Date: 13<sup>th</sup> April 2021

**Re: South West Milton Keynes, Updated Transport Assessment**

**Location: Land South Of The A421 West Of Far Bletchley North Of The East West Rail Link And East Of Whaddon Road Newton Longville**

**Junction 16: Elfield Park Roundabout – Mitigation Proposal**

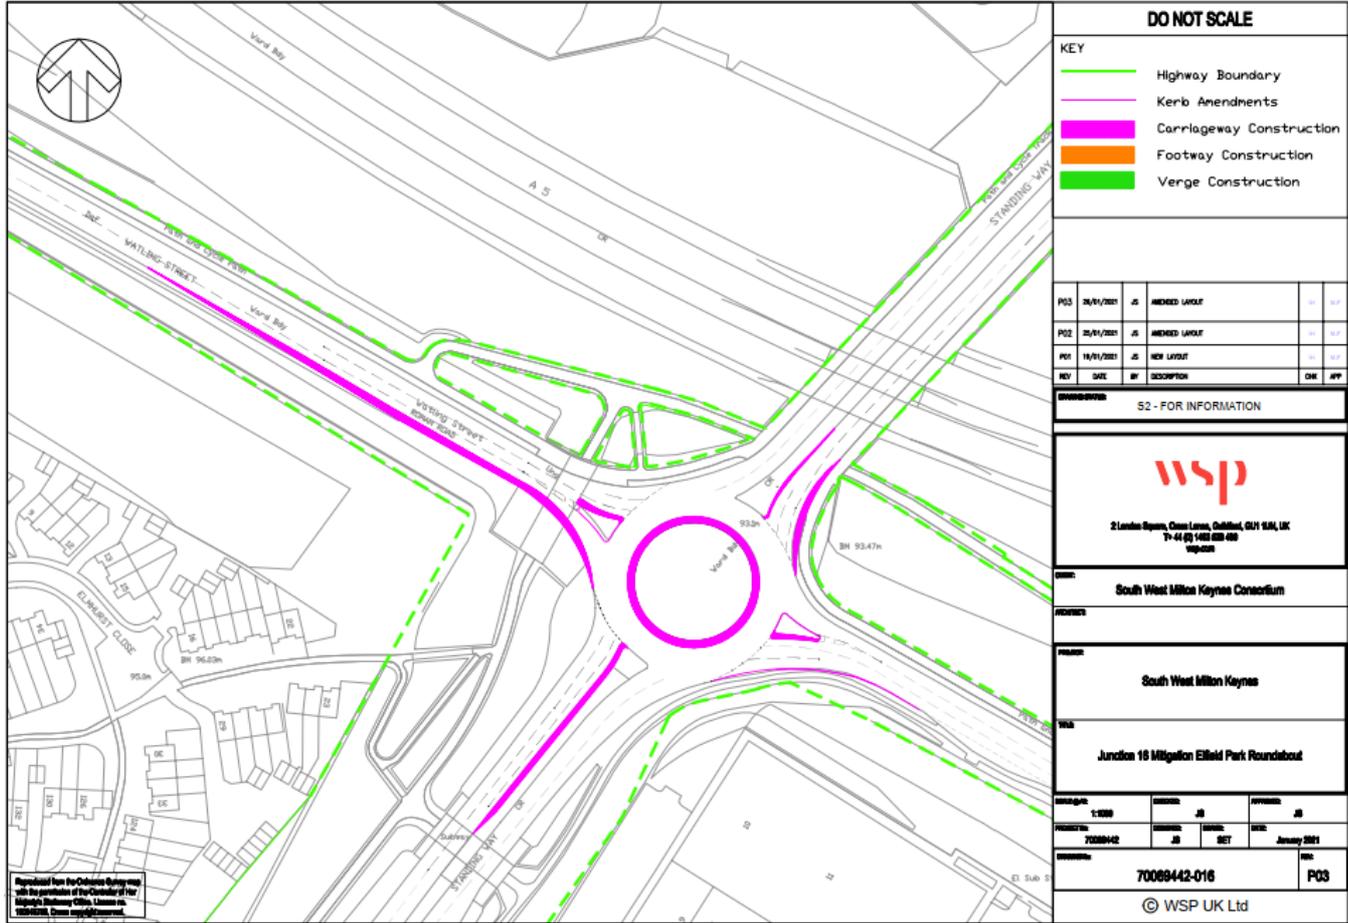
The predicted decrease in capacity due to development traffic would be considered significant and the Applicant has submitted a mitigation scheme. This includes kerb widening on all arms to improve capacity.

BC highways registered concern over the potential blocking back to J15 Bleak Hall roundabout. The Applicant provided a response on 7th April 2021. This highlighted further review of the junction flows used in the model and that only a slight reduction (5%) in network flow would result in no blocking back. It is agreed that a robust growth has been applied to the flows used in the modelling, with TEMPRO growth factor over 15% along with higher banded of employment rates to provide a 'worst case' flow scenario. The Applicant also made reference to the Department for Transport's 'Appraisal and Modelling Strategy – A Route Map For Updating TAG During Uncertain Times' (July 2020) which recommends the use of scenarios to assist with modelling future outcomes. Although the DfT has yet to publish updated forecasts, there is a clear indication of a downward trend in trips to account for the lower economic output.

**Junction 17: Emerson Park Roundabout – Further Mitigation Proposal**

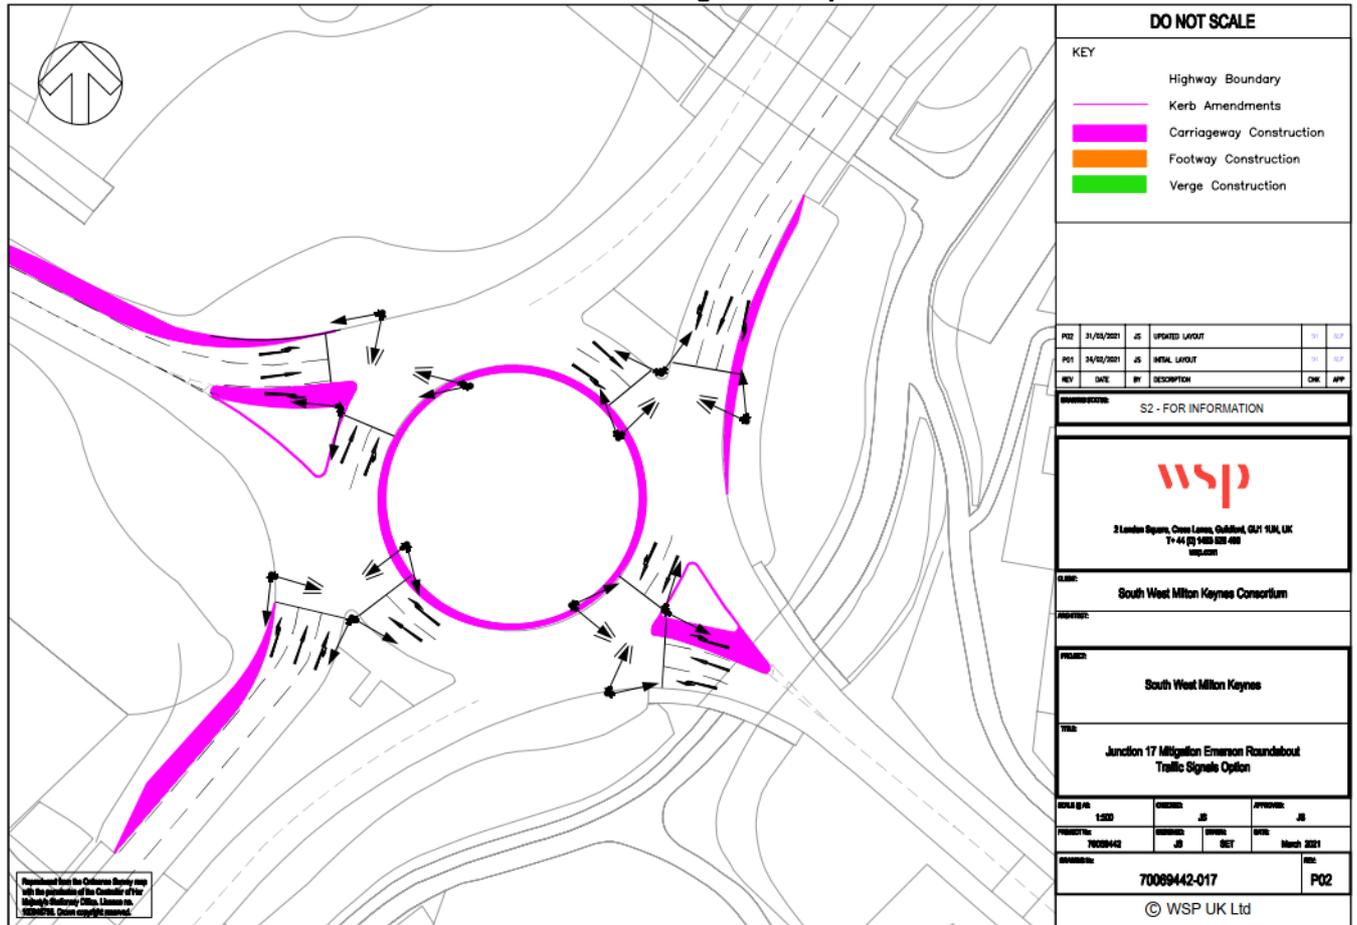
BC highways raised concern over the predicted negative impact on demand weighted Junction Delay in the PM and the resultant long queues on A421 Standing Way (N). The Appellant provided a response in a letter dated 7th April 2021. This provided details of a potential further mitigation measures that could be deployed at the junction, this involved conversion of the junction to part-time signal control.
